POUR/ZONE No. 206, 207	FLOW DIAGRAM P-311A
REQUIRED COMPLETION DATE 7/25/80	WELD PROCEDURE Q.S.I. SEE DES STAMP
FABRICATED BY TUBESCO	
NPS DESIGNS INC. NEW YORK, N.Y.	LIVSEY & COMPANY, INC. INDIANA & MICHIGAN ELECTRIC CO. DONALD C. COOK NUCLEAR PLANT
FABRICATOR NOTE: FABRICATION MUST CONFORM TO LATEST A.E.P. ARRG. DWGS.	DWN. 11/11/78 DATE 11/11/78 CONTAINMENT #2
	CKD. 06 DATE 11/11/78 DWG. NO. 2-NSW-188
	ISSUED 11/11/78 2-NSW-188
	REF. DWG. 2-5702 SHT. 2 OF 2

2-NSW-188 (Sheet 2 of 2)
Instrument Room Ventilation
Unit 3 Return Line

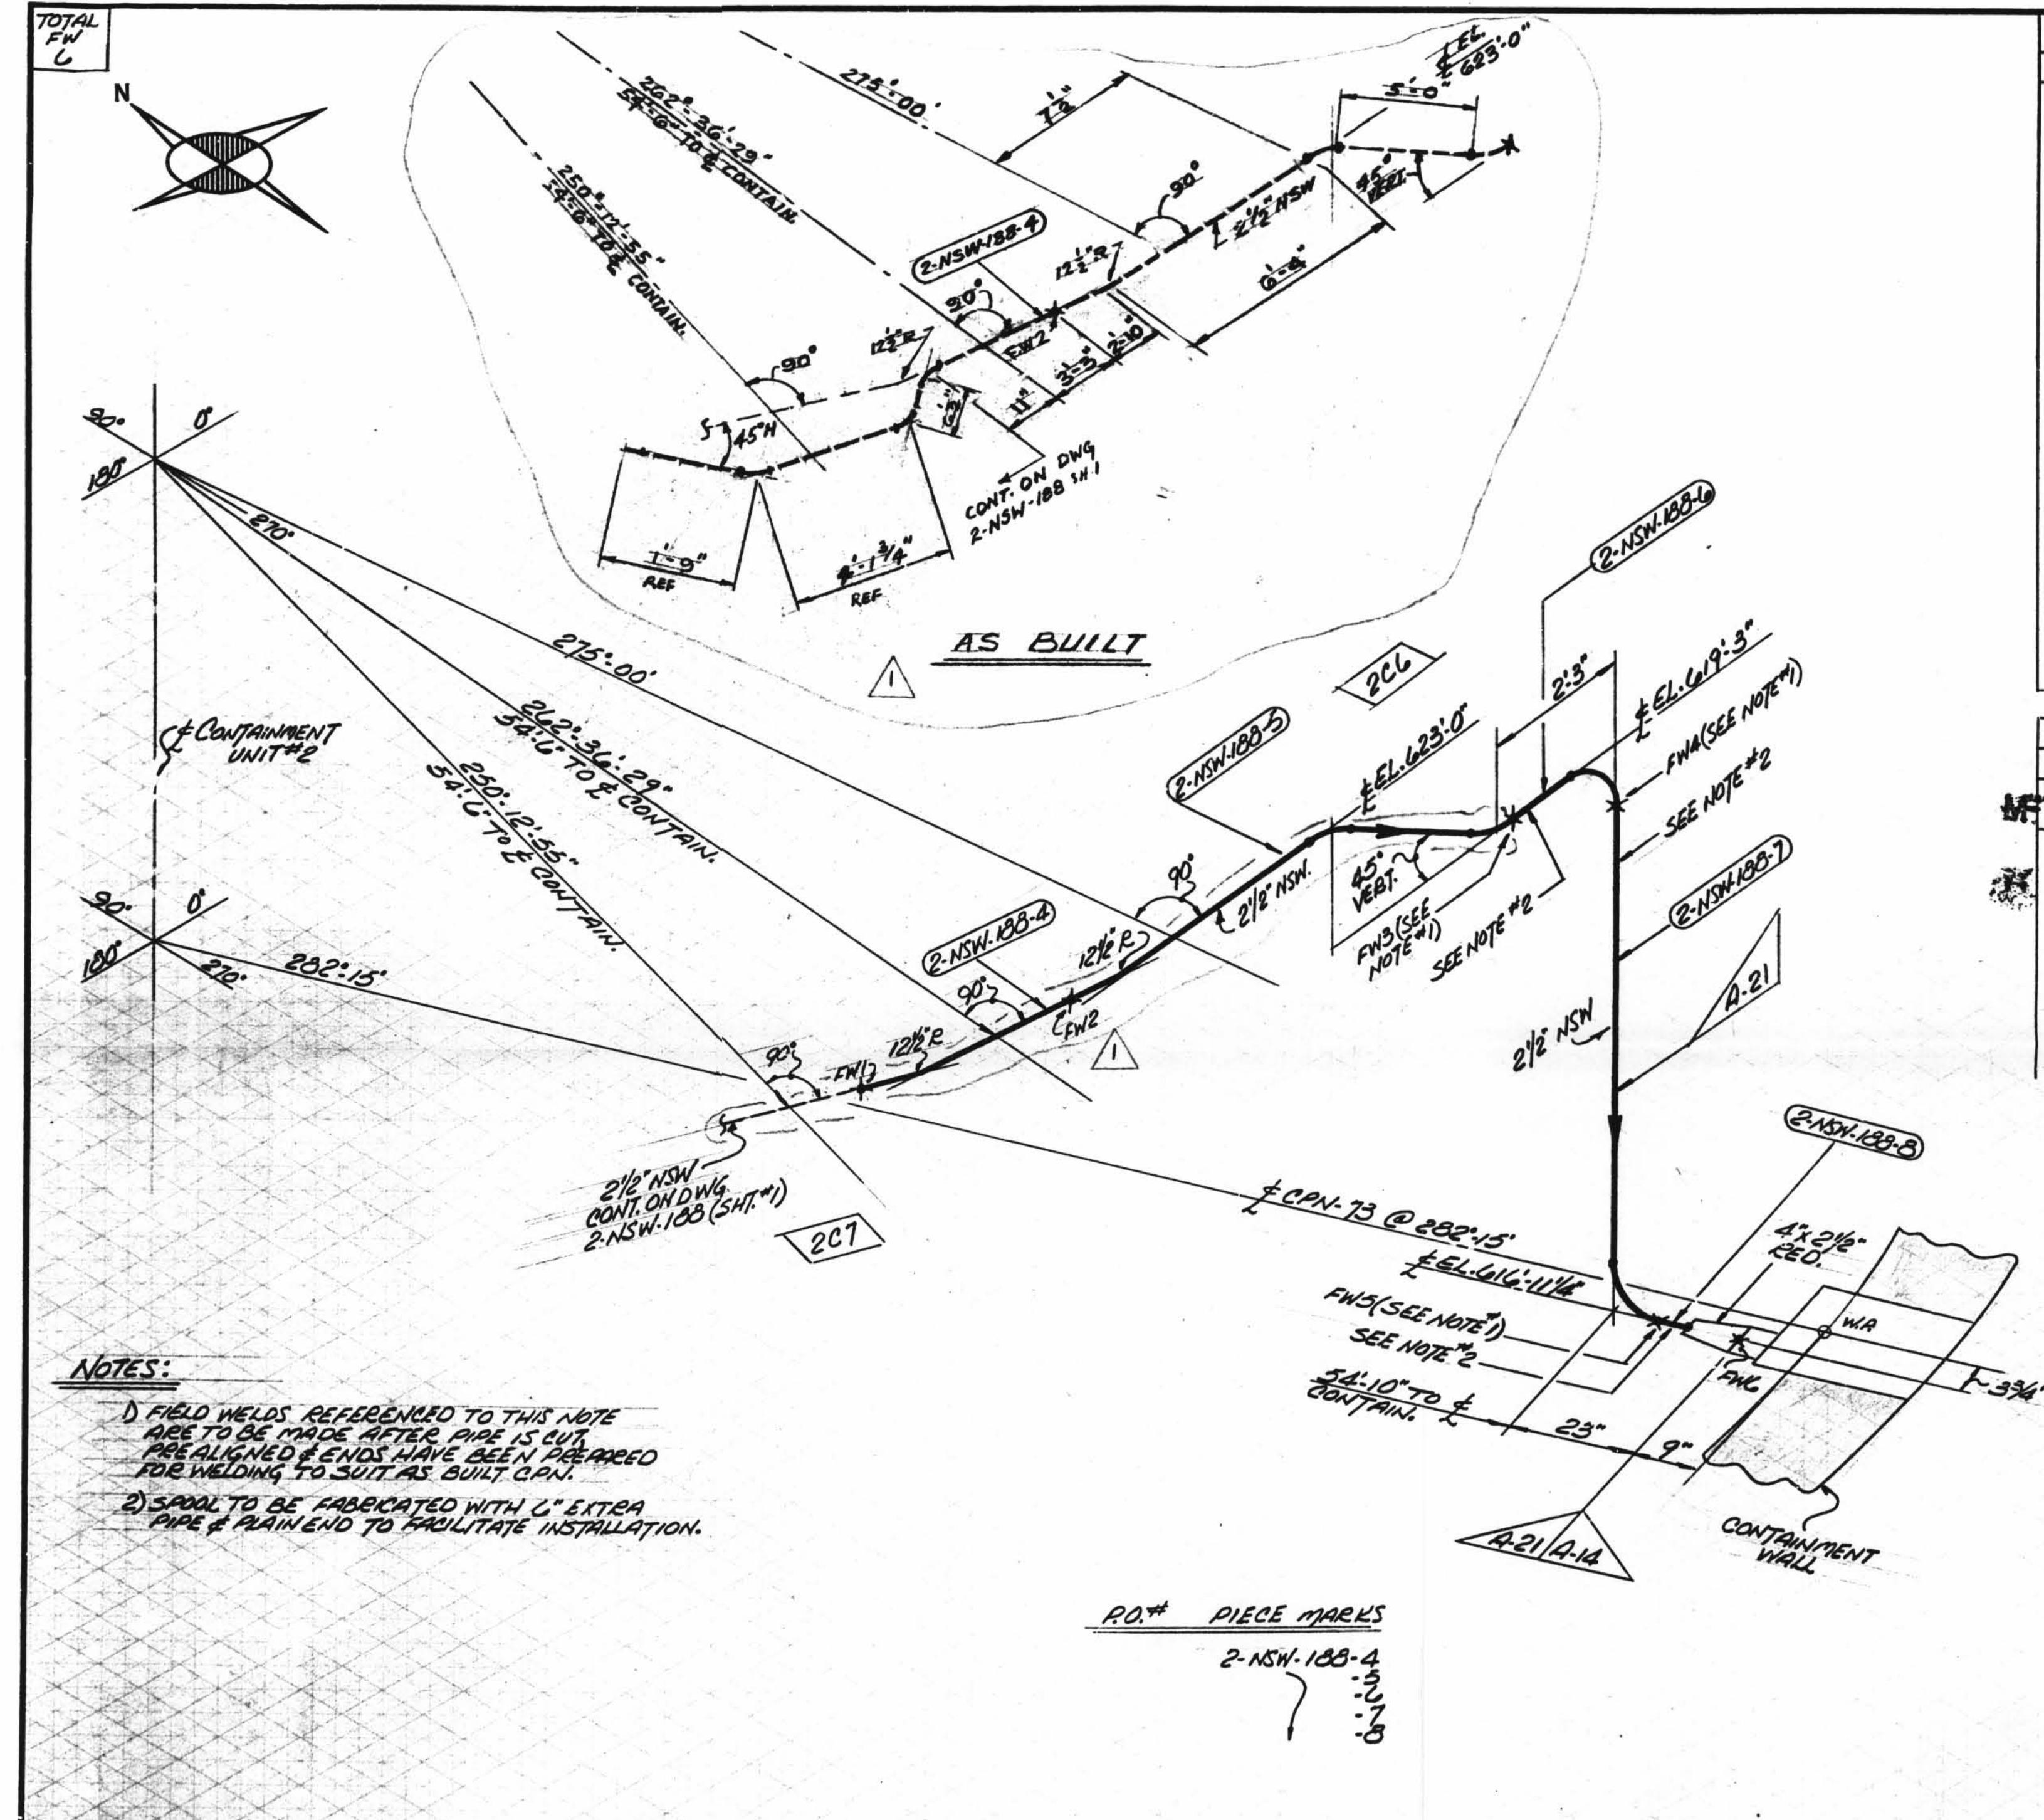
NO.	DATE	DESCRIPTION
1	11/31/78	PER RDM-MC-0582 ADDED AS BUILT DIMS. AND REVISED PIPING - DOTTED LINE INDICATES AS BUILT.

- FIELD WELDS REFERENCED TO THIS NOTE ARE TO BE MADE AFTER PIPE IS CUT. PRE-ALIGNED & ENDS HAVE BEEN PREPARED FOR WELDING TO SUIT AS BUILT C.P.N.
- SPOOL TO BE FABRICATED WITH 6" EXTRA PIPE @ PLAIN END TO FACILITATE INSTALLATION.
